3M Fall Protection

3M™ DBI-SALA COUNTERWEIGHT SYSTEMS (OSHA& CE)**PRODUCT RETROFIT NOTICE**

Counterweight System & center section Retrofit Part

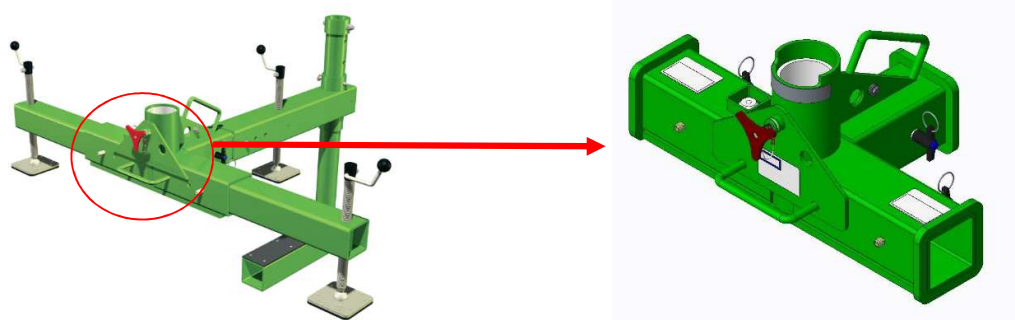
3M Fall Protection has determined that certain Counterweight Systems do not fully meet all load claims in all adjustment positions as represented in the “Instruction for Use” (IFU) manual and on product labels. There have been no reported accidents or injuries associated with this issue. This issue only affects the following systems: OSHA P/N’s 8300010, 8511892, 8512894, 8514496, 8520775, 8530088, 8530146, 8530226 8530256, 8530355 & CE P/N’s 8562894, 8564496. **Note, this is not a product recall.**

To address the issue, 3M Fall Protection has developed a design modification to one component common in all Counterweight Systems (center section P/N 8513593 OSHA or 8541688 CE). The modification has been incorporated in all Counterweight Systems manufactured after March 1, 2017, and will be available as a retrofit at no cost to all end users who purchased their systems prior to March 1, 2017.

End-users: Please contact Customer Service at +33 (0) 4 97 10 00 10 or email informationfallprotection@mmm.com to receive your Retrofit Kit free of charge. Retrofit Kits P/N’s are 8549057 OSHA and 8549058 CE. If you provide us with your contact information, shipping address, and model details of the system you have, we will send you the Retrofit Kit free of charge. When you receive the Retrofit, please follow the instructions for returning your affected center sections using the pre-paid mailing box. Updated IFUs can be found at <http://capitalsafety.webdamdb.com/#folder/2643471>. Please locate the appropriate IFU for your system.
